Dinorwig-Pentir – Consultation on the project’s Final Needs Case

Subject	Details
Publication date:	1 st June 2022
Response deadline:	1 st July 2022
Contact	James Santos-Mansur
Team:	Price Control Operations - Heavy scrutiny projects
Telephone	020 7901 7000
Email:	RIIOElectricityTransmission@ofgem.gov.uk

We are consulting on our views on the Dinorwig-Pentir cable and substation replacement project. We would like views from people with an interest in new transmission infrastructure, meeting the net zero challenge and competition in onshore transmission networks. We particularly welcome responses from consumer groups, stakeholders impacted by the project, stakeholders with an interest in the costs of electricity transmission infrastructure and the transmission owners. We would also welcome responses from other stakeholders and the public.

Figure 2: Dinorwig substation layout

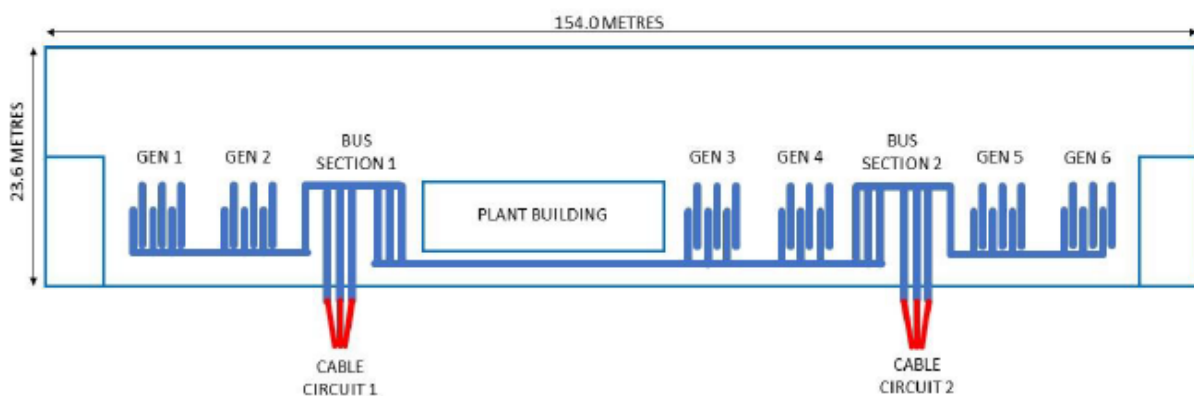
2.15. The majority of the equipment at Dinorwig substation is 40 years old and has a history of known issues associated with hydraulic leaks on some of the circuit breaker mechanisms.

2.17. There have been a number of defects on the Dinorwig GIS. The most common defect has required SF6 ‘top-up events’ due to high leakage rates and there have also been other defects involving hydraulic mechanisms and control systems.

2.18. Table 3 below shows that the EoL scoring process (EoL modifier) presently puts the forecasted EoL for circuit breakers X120 and X205 sometime before the end of RIIO-2 (on 31 March 2026). This is driven by age versus expected life and SF6 emissions.
